- Subject** ▶ Change of Power Supply Cord, etc.
- For Models** ▶ 1804K, 1804N, 2012, 2416S, 2708, 2711, 3600H, 3701,3702, 420S, 5103N, 5201N, 5500S, 6910, 906H, 9803, 9804, DA6300, HM1201, HM1302, HR3811
- Country** ▶ Germany, Sweden, Russia, South Korea
- Description** ▶ As described below, Power Supply Cord has been changed because the current Cord cannot be supplied by its manufacturer.  
Accordingly, Cord Guard and Strain Relief have been changed at the same time.

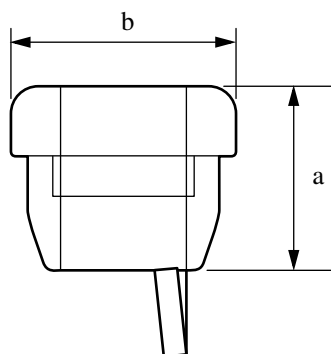
► Current	► New	MODEL
Power supply cord		DRAKA (QR) 3 wires, outside dia.:ø9.3mm rubber, with molded plug	EN (H07RN-F) 3 wires, outside dia.:ø9.0mm rubber, with molded plug	All Models
Cord Guard  		Part No.682550-3 Inside dia : ø10mm Neck dia. : ø19mm	Part No.682540-6 Inside dia : ø9.3mm Neck dia. : ø19mm	1804N, 2708, 2711, 5103N, 5201N, 6910, HR3811
		Part No.682505-8 Inside dia : ø10mm Neck dia. : ø19mm		5500S, DA6300
		Part No.682504-0 Inside dia : ø10mm Neck dia. : ø17mm	Part No.682516-3 Inside dia : ø9.3mm Neck dia. : ø17mm	9804
Strain Relief  	Pitch 20mm	Part No.687052-4 	Part No.687053-2 	2708, 5103N ,5201N
	Pitch 15mm	Part No.687001-1 	Part No.687000-3 	1804N, 2416S, 2711, 6910, DA6300, HR3811
		Part No.687004-5 	Part No.687006-1 	5500S

## Change of Strain Relief

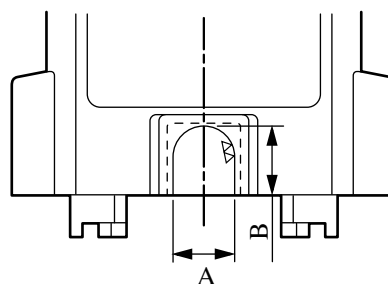
CURRENT	NEW
Part No.	687008-7	687105-9
Length a	14.9 mm	19.1 mm
Length b	16.4 mm	19.8 mm
Indication Mark	KG,KR-61A	HEYCO,7P-2
